September 17, 1979

Perry Mann - Southern Region PCM

St. Clair Co. - LPC 163 045 01 - E. St. Louis/SCA-Milam
Investigation of the final cover at the "old site", west of Cahokia Creek.

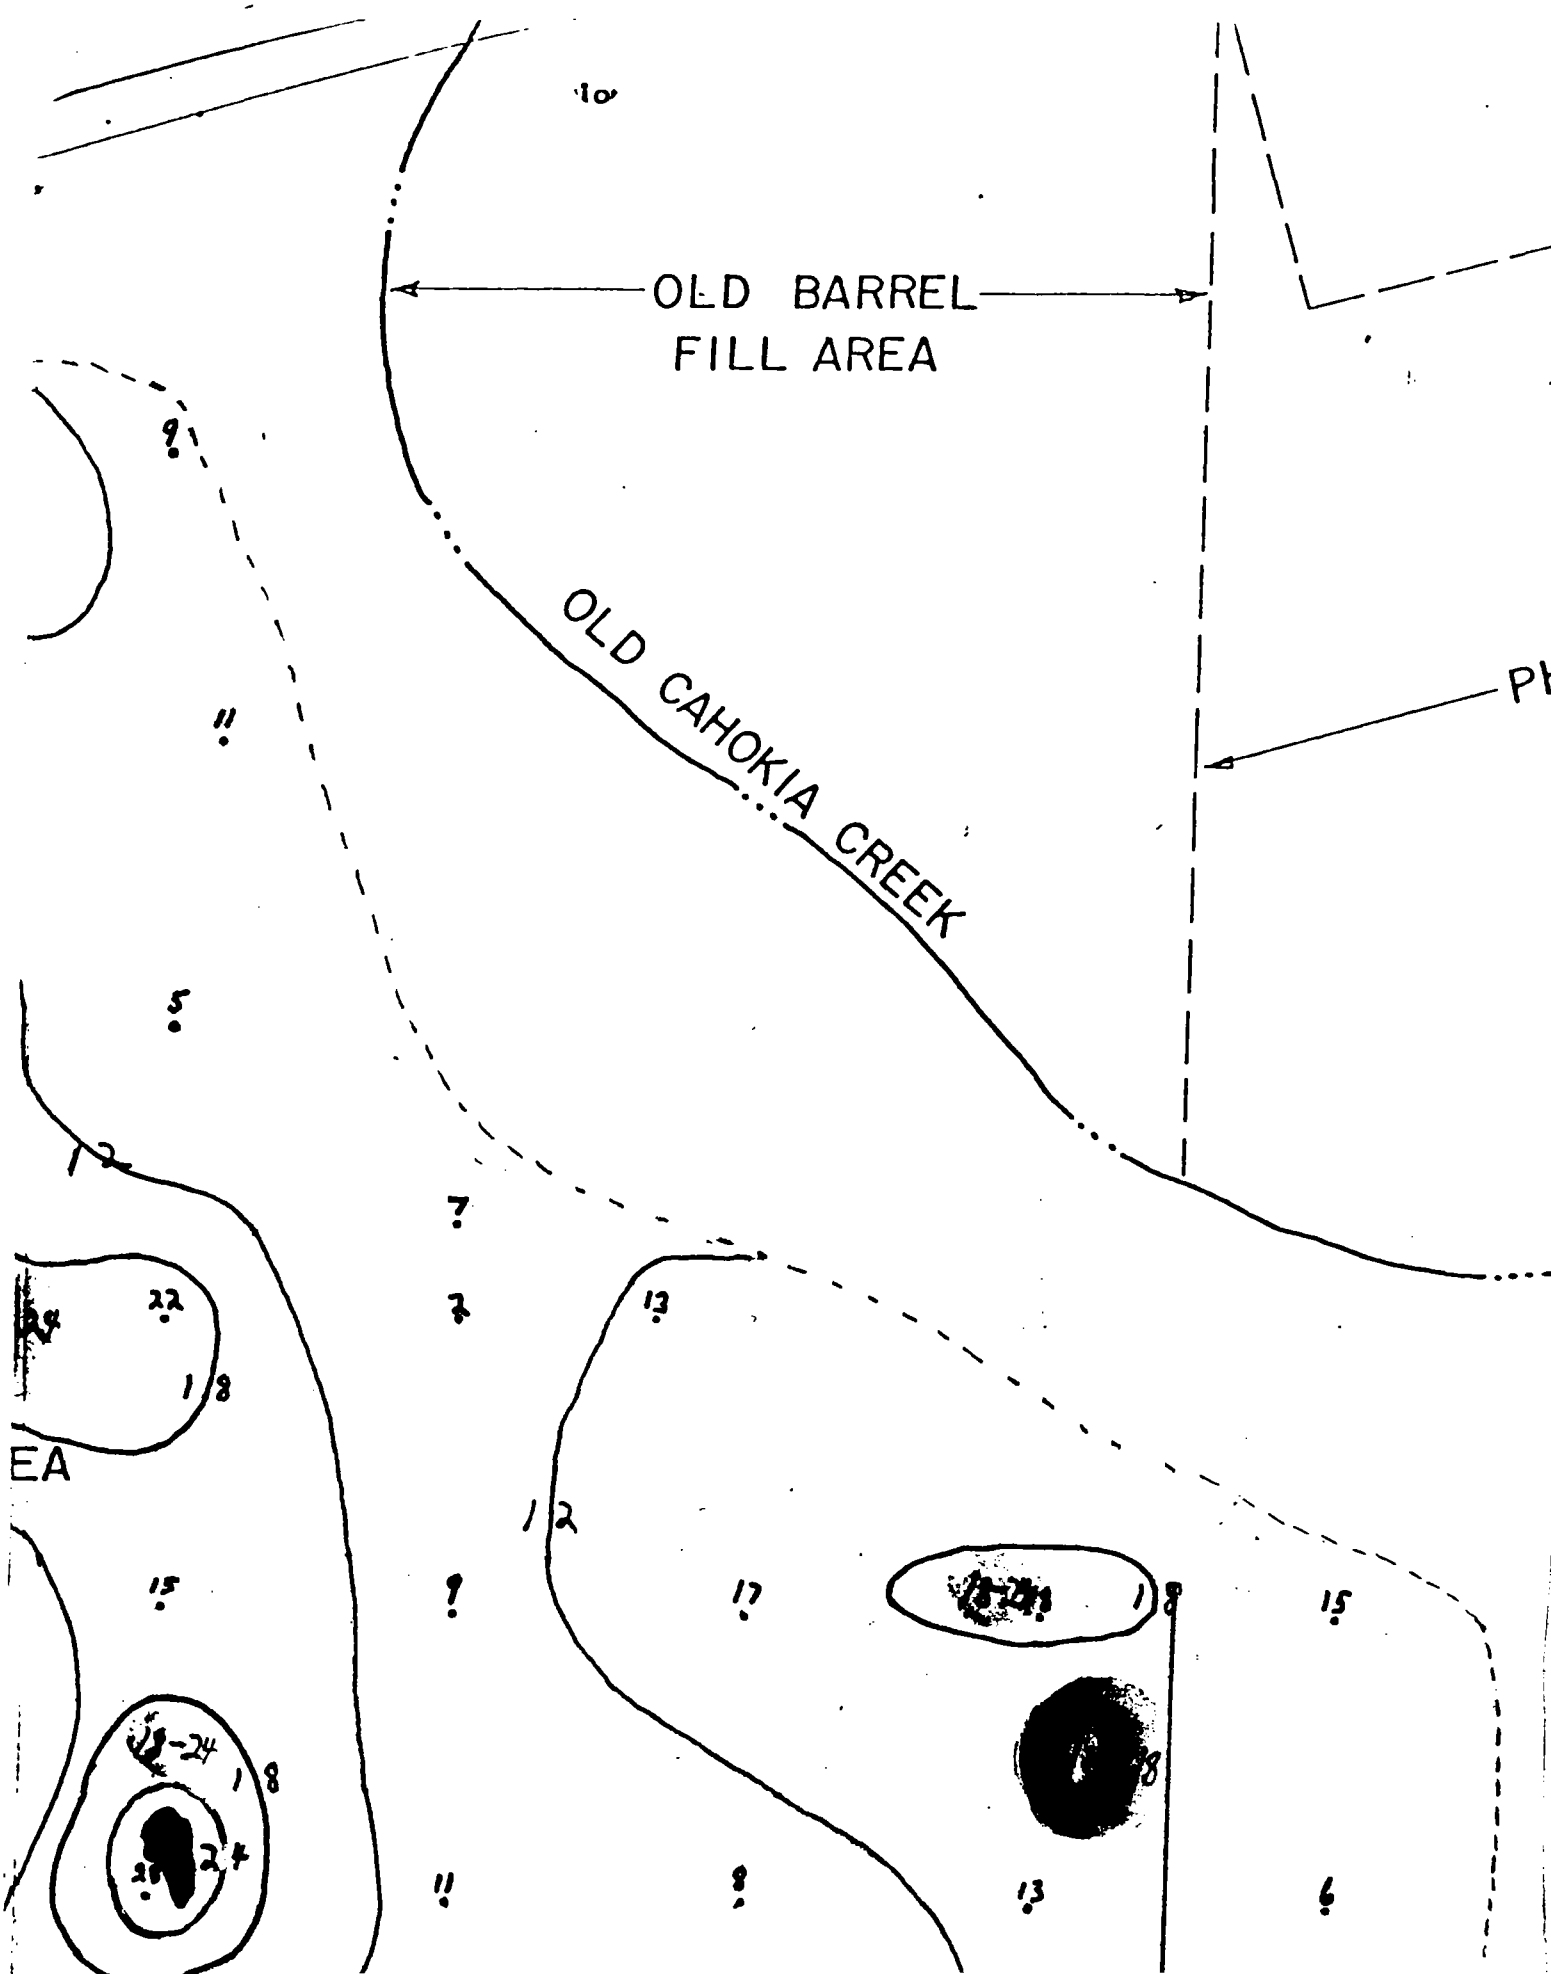
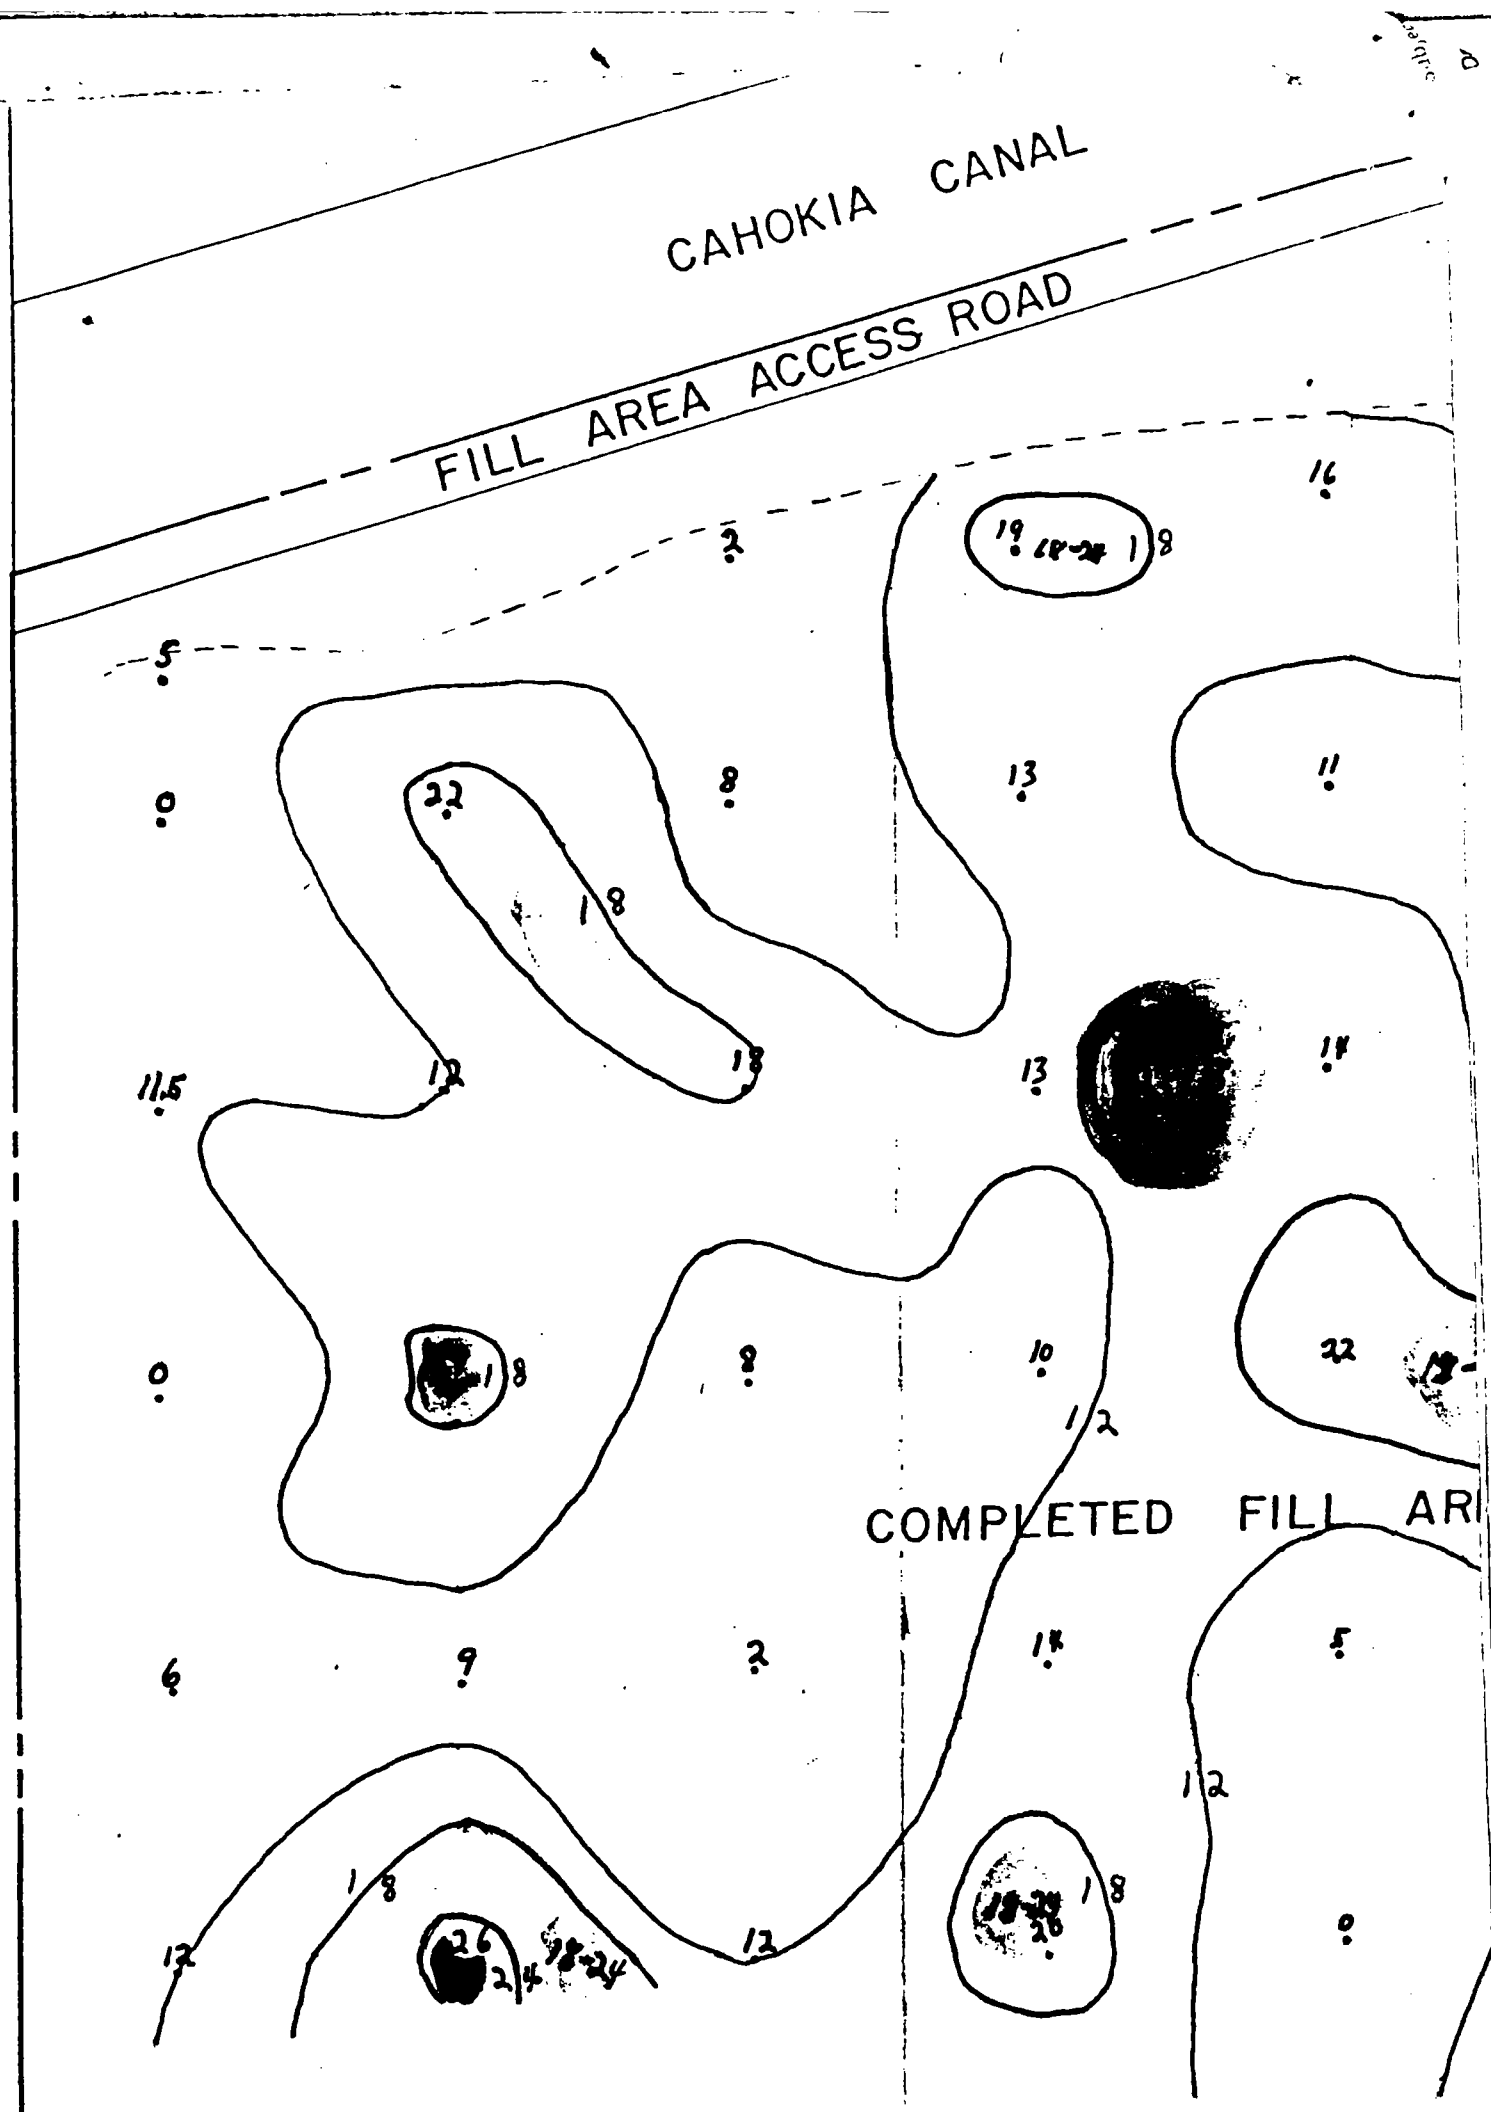
The uncolored portions of the map within the sites boundaries are the areas having 12 inches or less of suitable cover material (clay, no sand). The portions shaded in yellow have more than 12 inches but less than 18 inches of cover. The green areas are those having between 18-24 inches while the orange portions are areas exceeding the 24 inch final cover requirement.

As shown on the map a large portion of the site has probably less than 12 inches of suitable cover. Nearly one half of the total number of borings done were found to have less than 12 inches of cover. Sixteen (16) of the forty-six borings had 12-18 inches of cover, inclusive. Of the remaining borings, only six (6) were found to have 18-24 inches; two had cover exceeding 24 inches.

In conclusion, in the 90-95 acres of the old fill represented by the 46 borings made on September 12, approximately one-half of the area has less than 12 inches of the 24 inches required for final cover. Only some small areas indicate that they have the 24 inches of suitable cover material required.

It therefore must be concluded that the final covering of the "old site" has <u>not</u> been completed and may even require more than 152,000 cubic yards to adequately cover the areas of the site in which the borings were made.
